## CONSTRUCTION DOCUMENTS REVIEW

RE: QUIZNOS SUB #11329  
Meridian Crossroads  
Highway 19 and I20 Shop 204  
Meridian, MS 39301

FINISHES PLAN  
SCALE: 1/4" = 1'-0"

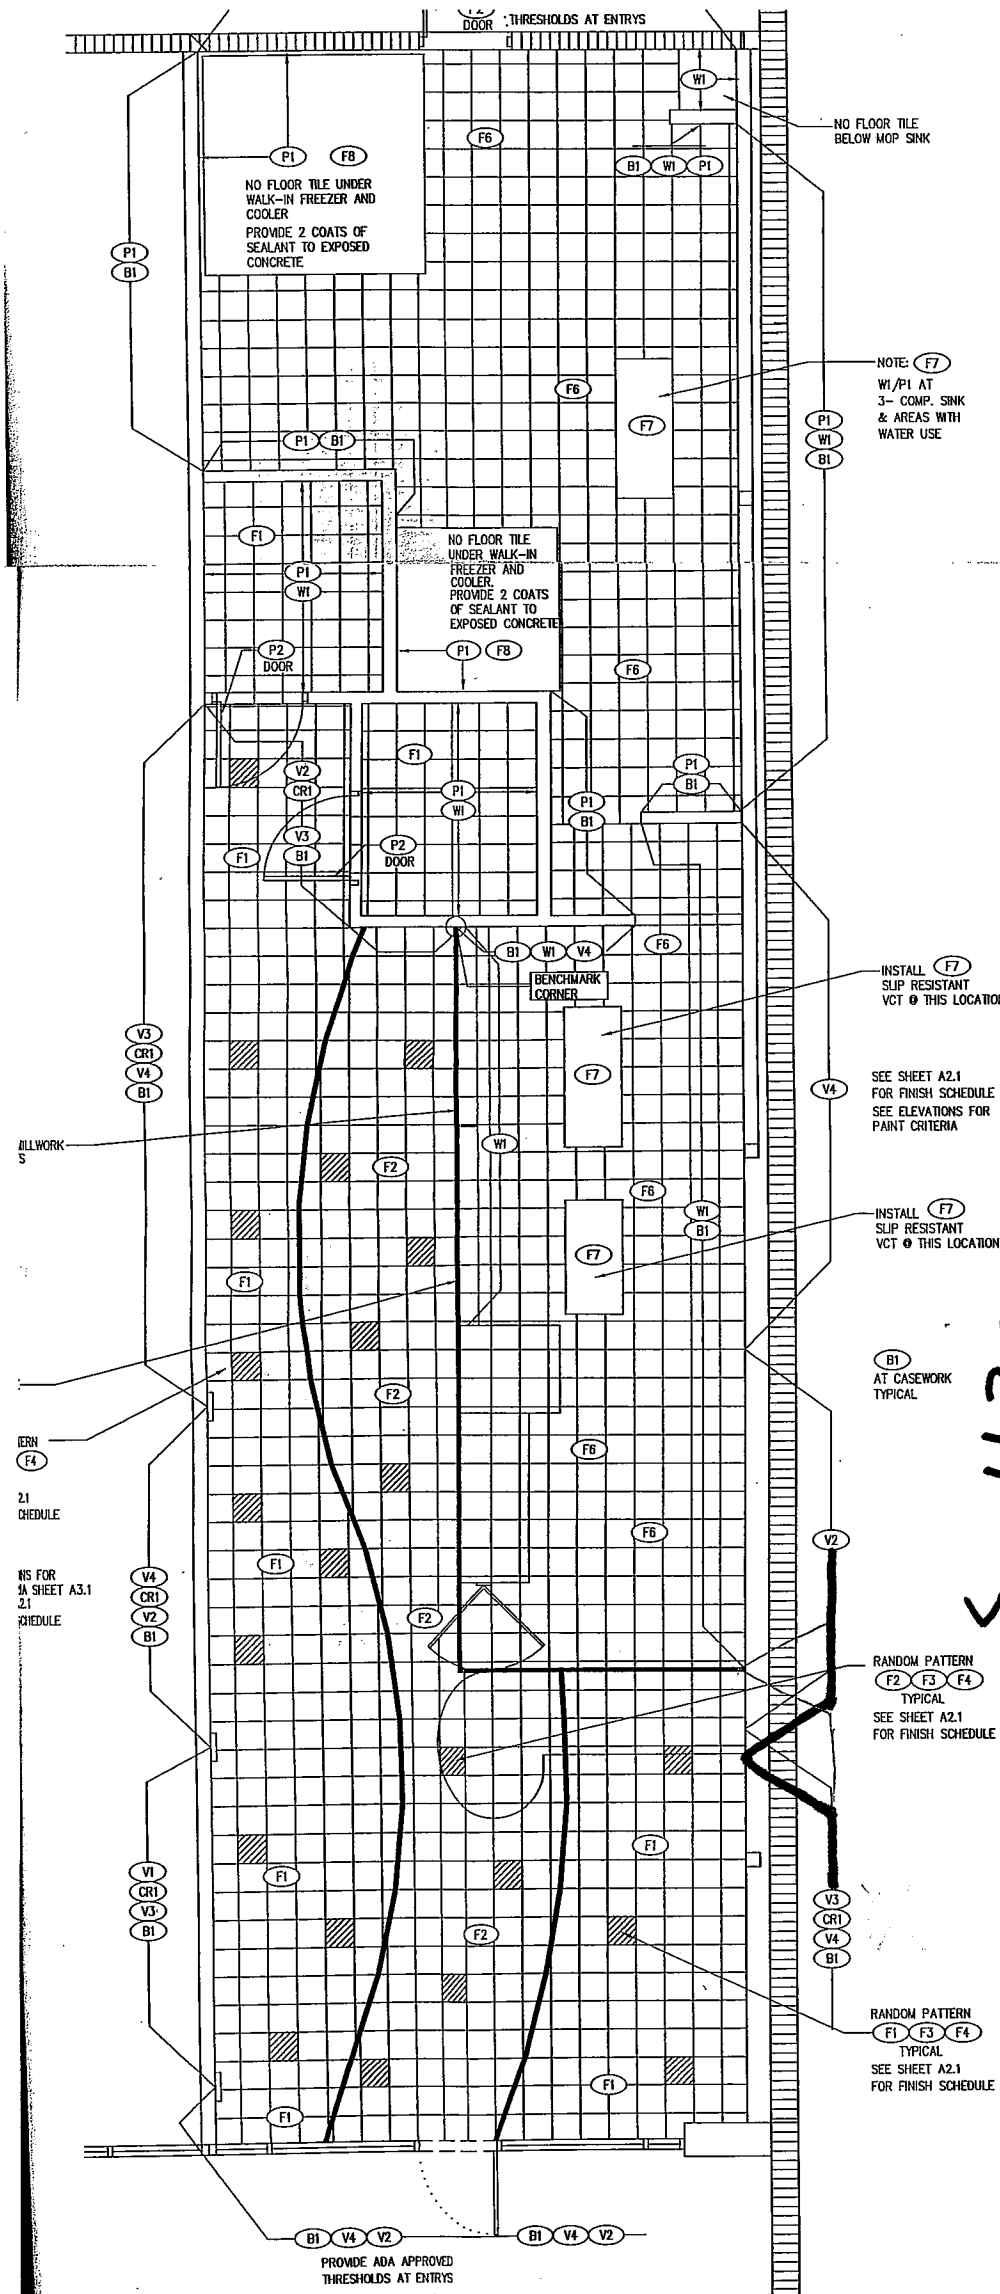
- \*c. **Refer to prototype for correct wall covering placement.** "V2" to be place behind the soda and ice machine.
  - d. A standard Q-Vent will be ordered per the QVent worksheet.

V2 behind soda machine
